SMARTCODE BUILDING/SITE PLAN APPLICATION (ARTICLE 5)

Nine Springs Building/Site Plan Submittal - Lots 12 & 13

Application: SmartCode Article 5
Property Address: 2800 S Syene Road (Lot 13), 5150 E Cheryl Pkwy (Lot 12)
Review Date: October 1, 2012
Planning Staff Review #3

Planning staff has reviewed the revised SmartCode Article 5 application submitted for Lots 12 & 13 of the First Addition to Nine Springs Plat submitted on 9/28/2012. The following comments are based on this review. These items will need to be satisfied before the Article 5 Plan for these lots can be issued. Further comments or questions may arise as additional review occurs.

Drawing Title
Site Plan

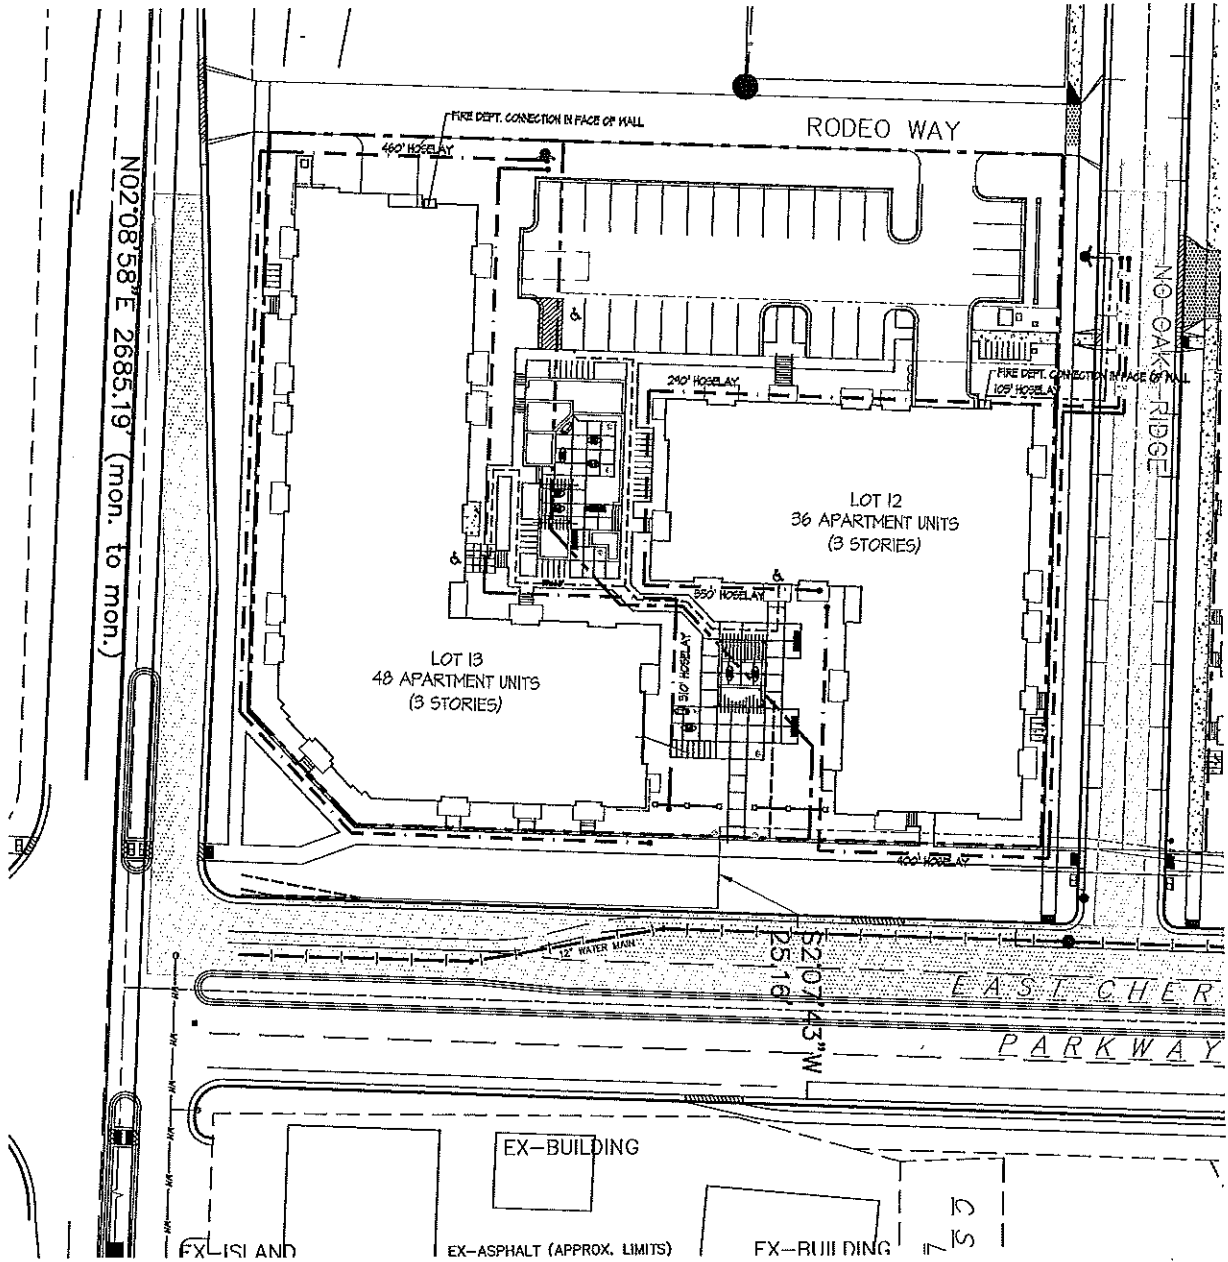
1. Sheet C-1.1 shows an 18' pavement width for Rodeo Way. An Administrative Waiver will be required to reduce the pavement width below the required 24'. Please submit a Waiver request or revise the plans to meet the required 24' width. **See attached Administrative Waiver.**

6. All plan sheets should be updated to be consistent with the revised site plan sheet C-1.1, specifically the change to the bike parking stalls on the northeast side of Lot 12. All sheets should show the 9 bike stalls, as shown on C-1.1. Please revise plan sheets accordingly. **Civil and landscape plans have been updated to match C-1.1.**

8. Does sheet C-1.1 show the final controller and transformer locations? **Final controller and transformer locations are shown on C-1.1.**
9. Have you met with the Fire Department? This approval does not guarantee the fire or building inspection approvals. **The owner and architect have met with the Fire Department.**

Drawing Title
 Site Lighting Plan

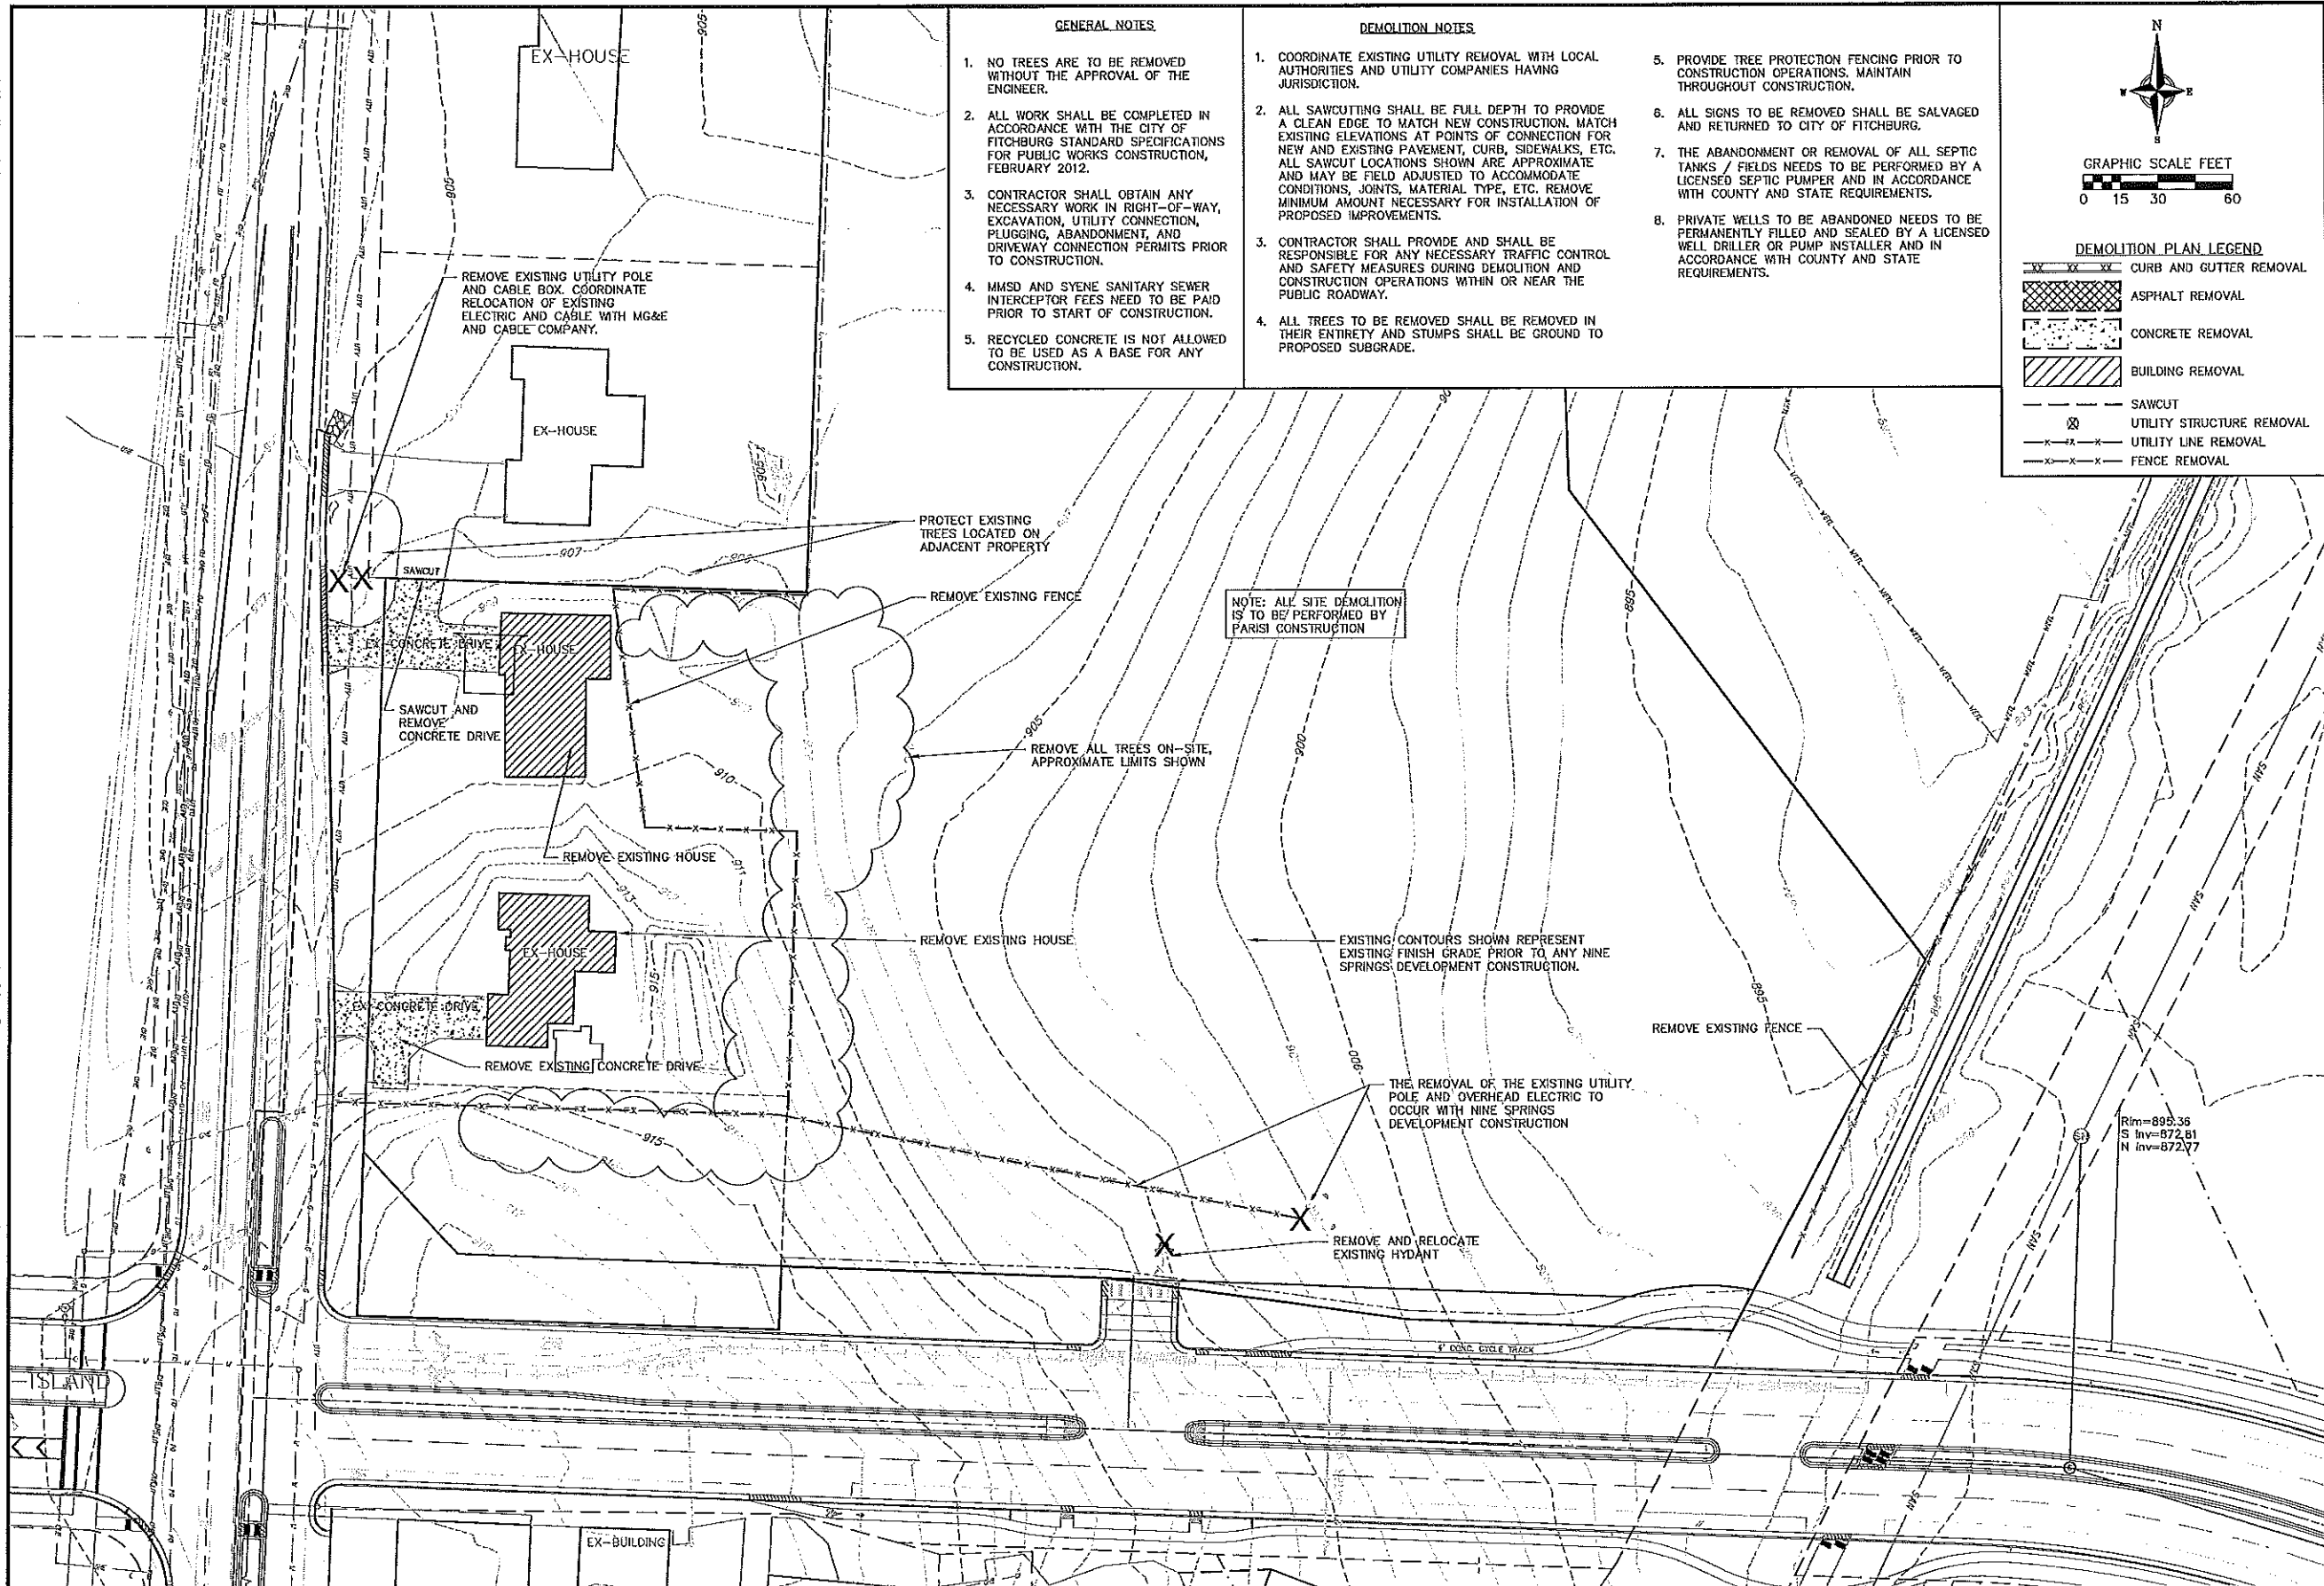
4. Some of the lighting cut sheets provided in submittal do not fully match the lighting schedule catalogue numbers on sheet C-1.3. Also, has lighting fixture E been determined yet? The plan sheets note that E is TBD. **See sheet C-1.3 for updated schedule. Updated cut sheets are attached.**
